ADDENDUM NO. 1

DATE: 5/24/2024

PROJECT: Old School Park - McCordsville

Addendum No. 1: Pages 1 - 2

Column/Footing Detail Final Size TBD Concrete Pier By Others

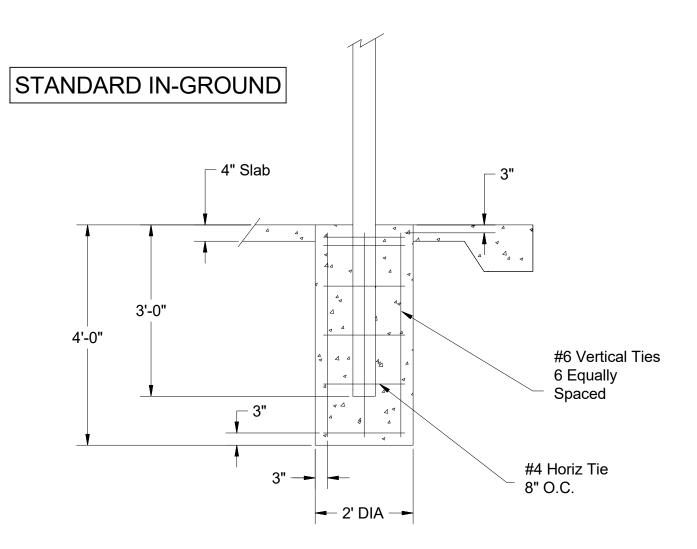
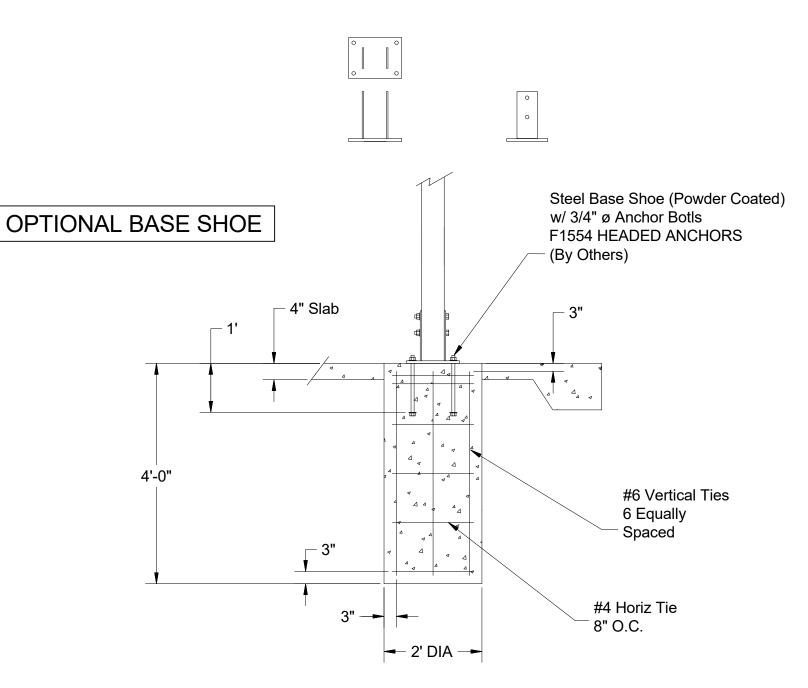
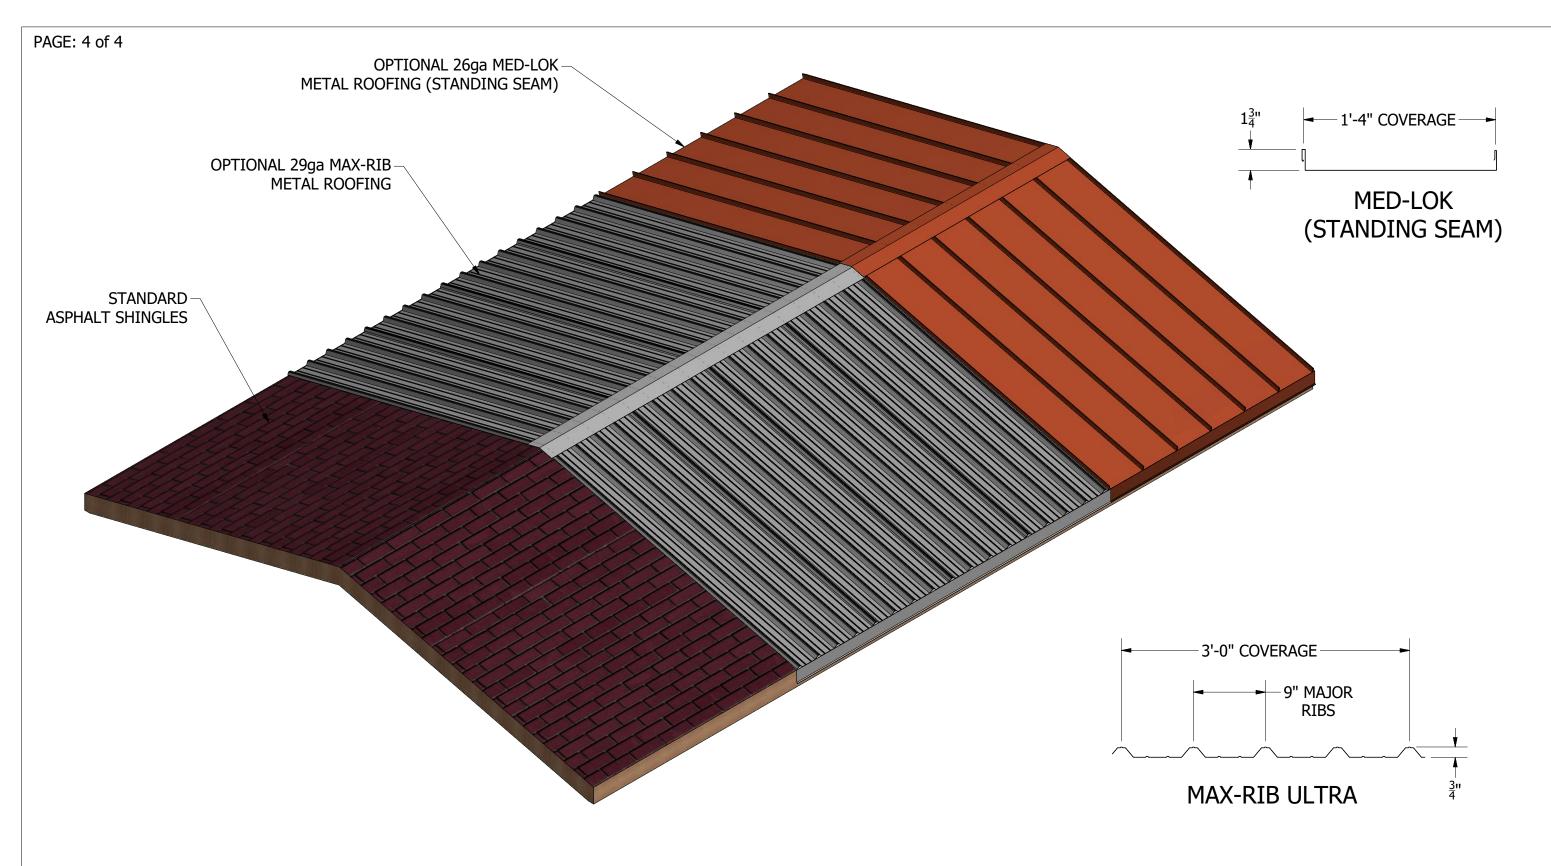
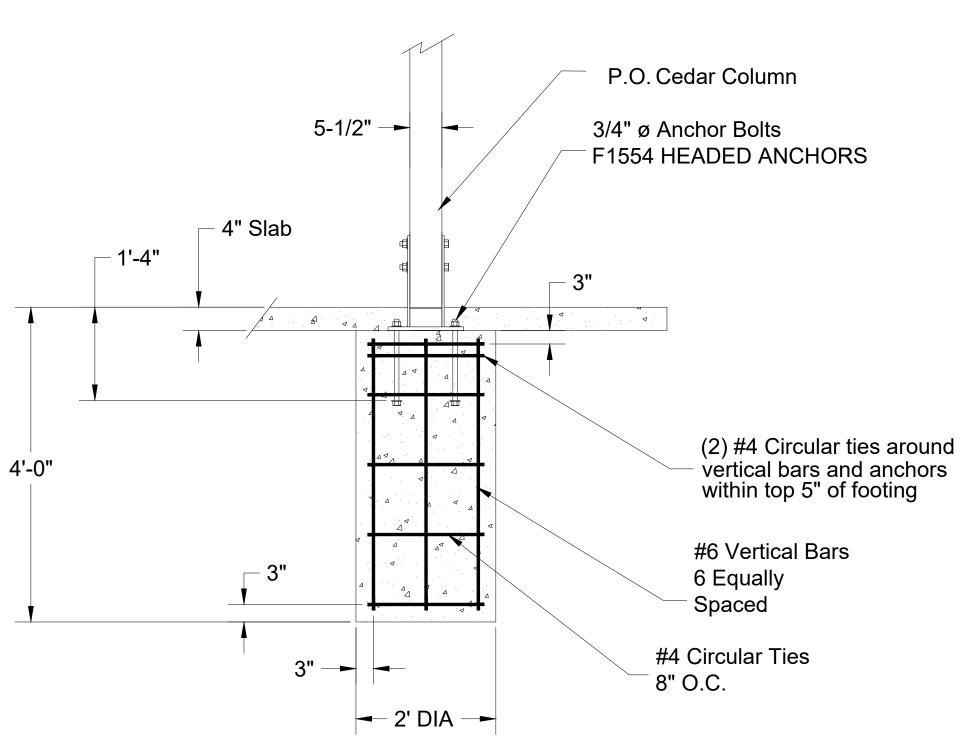
2. I understand the Open Air Shelter and Pre-Fabricated Restroom Bldg is Owner Furnished but is that vendor also providing the foundations that spec section 01100 indicates and if not the contractor needs a preliminary foundation design for bases of bidding and installation.

Response: Base information is attached for the Open Air Shelter. This shows the preliminary footings and the final concrete slab. GC could also choose to install the structure. This information will be incorporated into the plan set in Addendum #2.
